Addendum No. 1
December 6, 2022

Shared Use Path on SR270 to Stadium Way
Pullman, WA

Project No.9705-2018
Washington State University
Facilities Services, Capital

**Shared Use Path on SR270 to Stadium Way
Washington State University
Pullman, WA**

SP-7

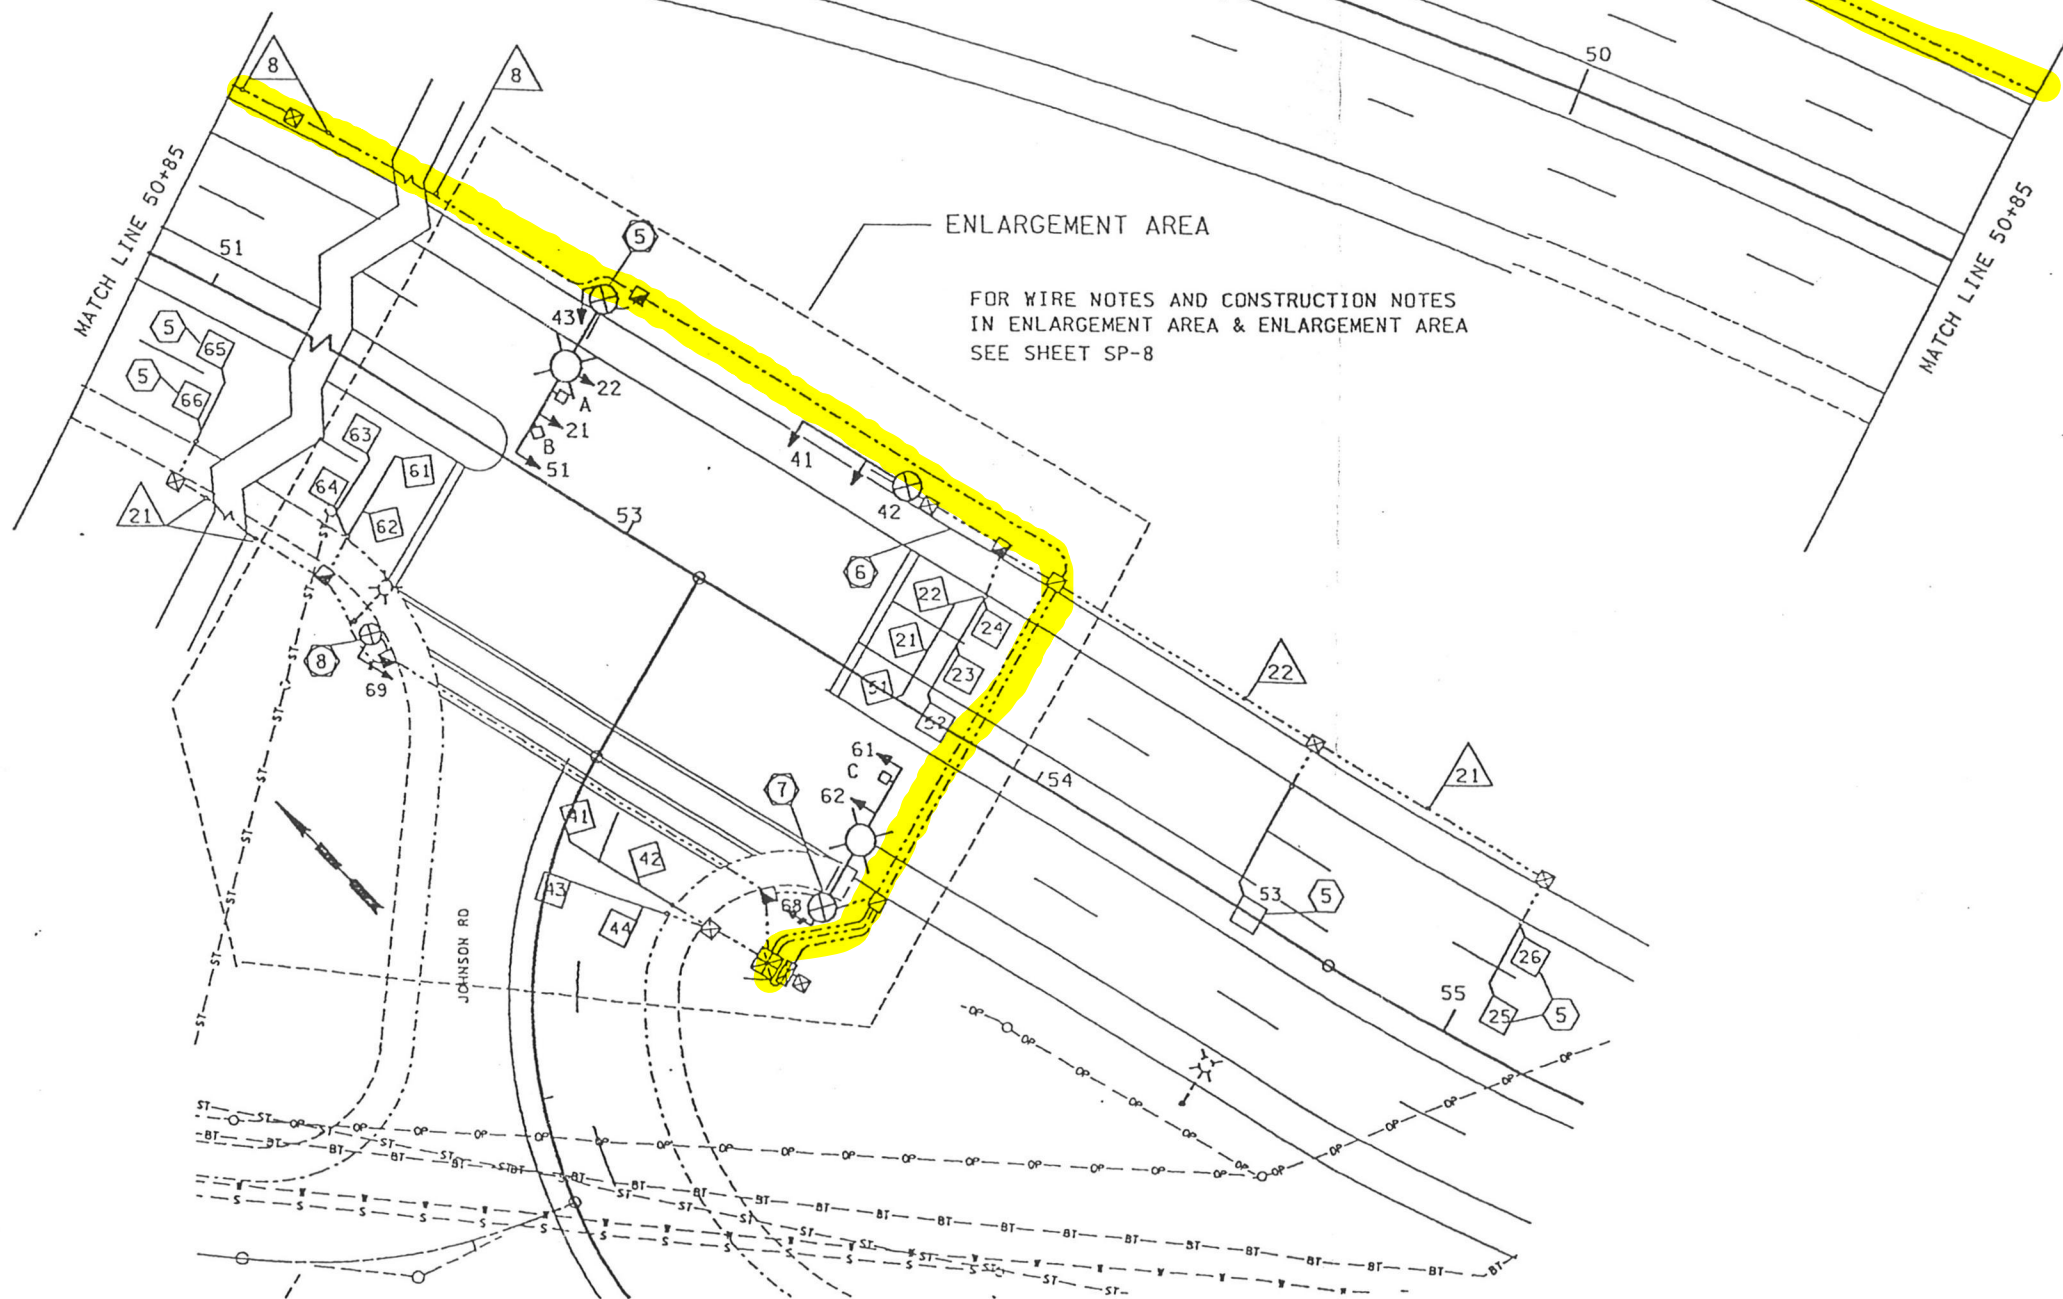
- f. Comment: Contractor shall maintain signal wires and pull-boxes along SR270. Pull-boxes will be adjusted to grade as needed. See attached drawing provided by City of Pullman
- g. Comment: New fencing shown on project drawings shall be per WSDOT Standard Plan L-20.10-03e. See attached WSDOT drawing and revised specifications.
